Our Case Number: ABP-313182-22

Re: BusConnects Clongriffin to City Centre Core Bus Corridor Scheme

# **SID Online Observation**

### RE: Clongriffin to City Center Core Bus Corridor (Case: 313182)

#### **DUBLIN JUNCTION WITH CORNER ISLAND**

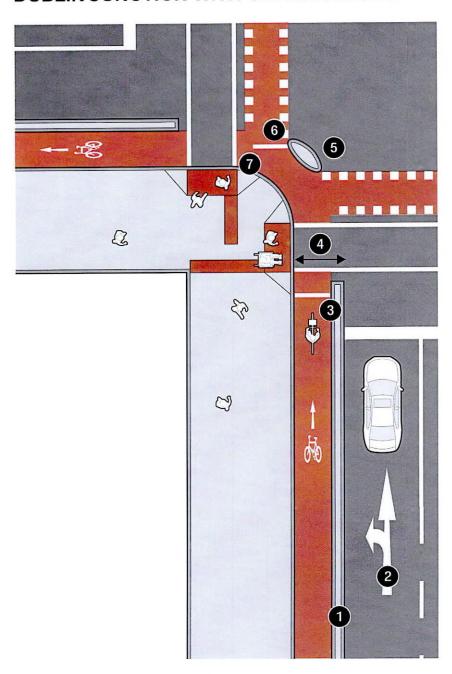
Junction Type 1-3, known as the Dublin-style junction, does not follow any international standard. It has been created by the National Transport Authority (NTA). People cycling will be crossing the junction at the same time as left-turning motor traffic. This can lead to 'left-hook' collisions for people cycling.

The National Transport Authority will not live up to their responsibilities as a Road Authority under the Roads Acts by building unproven Junction Type 1-3. The only two examples of the NTA junctions Type 1-3 have safety issues. There are proven international standards that the NTA could use for all junctions on this project instead.

#### **DUTCH JUNCTION**

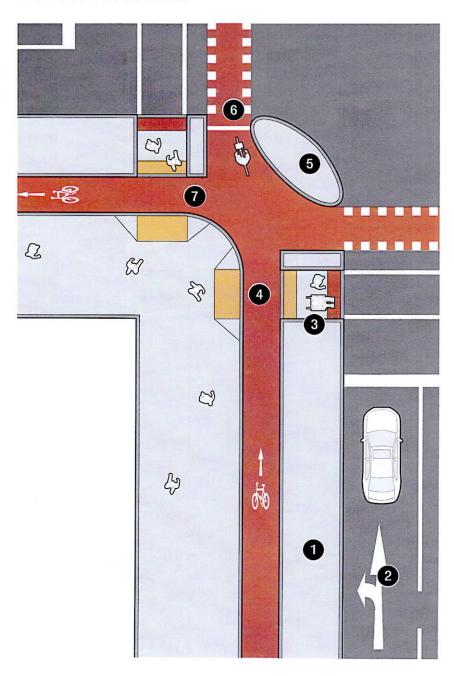
In previous design iterations of BusConnects core bus corridors the NTA have also proposed Dutch-style junction designs. It has similar properties to the Cyclops junction design. However, Dutch-style junctions do not feature in this application. This Dutch-style junction design has been used successfully for decades in the Netherlands, and is in use in 14 other countries worldwide. There are examples in Ireland. There is a Dutch-style junctions in Wicklow town at the junction of R999 / Hawkstown Road, which was constructed two decades ago. Another example is the new junction at Drummartin Link Road / Lower Kilmacud Road in DLRCC.

#### **CYCLOPS JUNCTION**

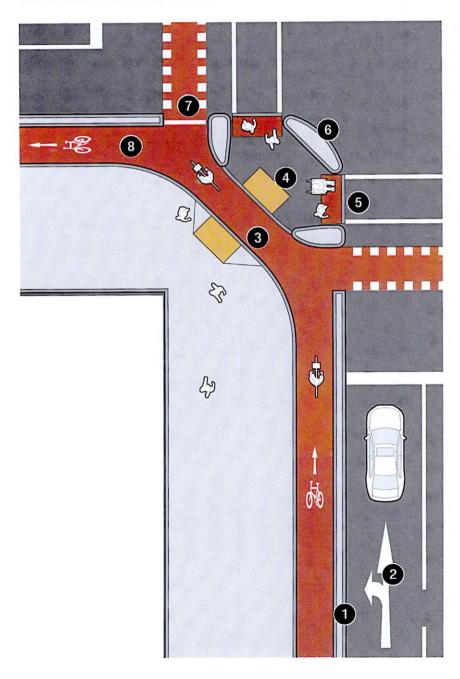
Junction Type 4, known as the Cyclops Junction, follows the international standard pioneered in the UK. The key element for people cycling is that they cross the junction under green signals at the same time as pedestrians. Cyclists don't cross the junction at the same time as left-turning motor traffic. This eliminates one of the most frequent cycling / motor traffic collisions, the 'left-hook'. As pedestrians and cyclists cross at the same time it improves junction efficiency and reduces wait times for all modes.

# **DUBLIN JUNCTION MOVEMENT SEQUENCE (A)**

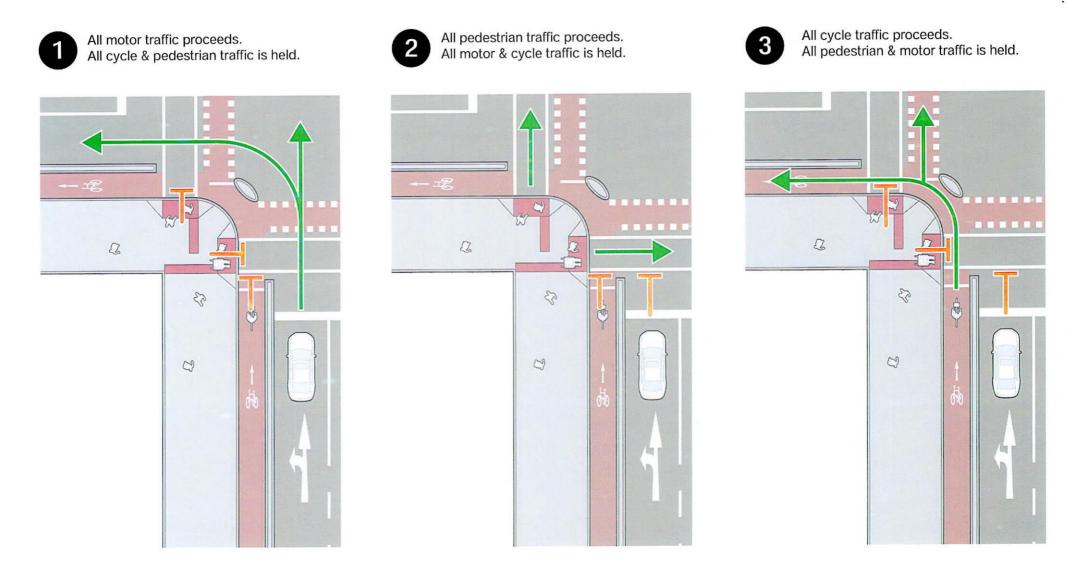
NOTE: Interupting the cycle lane with the controlled pedestrian crossing will add an extra 5m to the pedestrian crossing span.

## DUBLIN JUNCTION MOVEMENT SEQUENCE (B) (NOT SAFE FOR LARGE OR BUSY JUNCTIONS!)

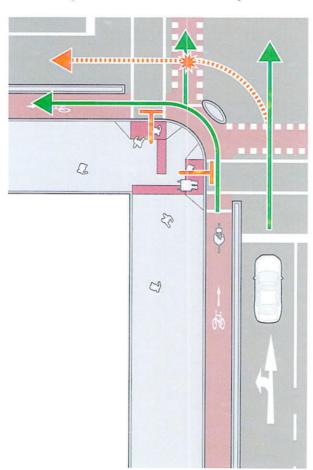
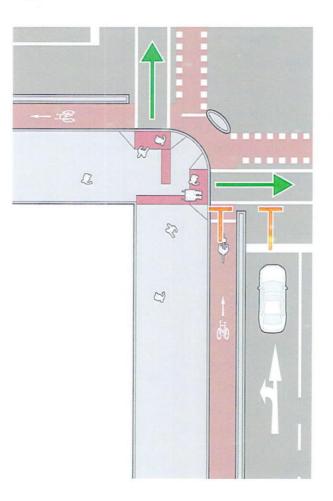
All motor & cycle traffic proceeds.
All pedestrian traffic is held.
High risk of conflict between cycle and motor traffic.
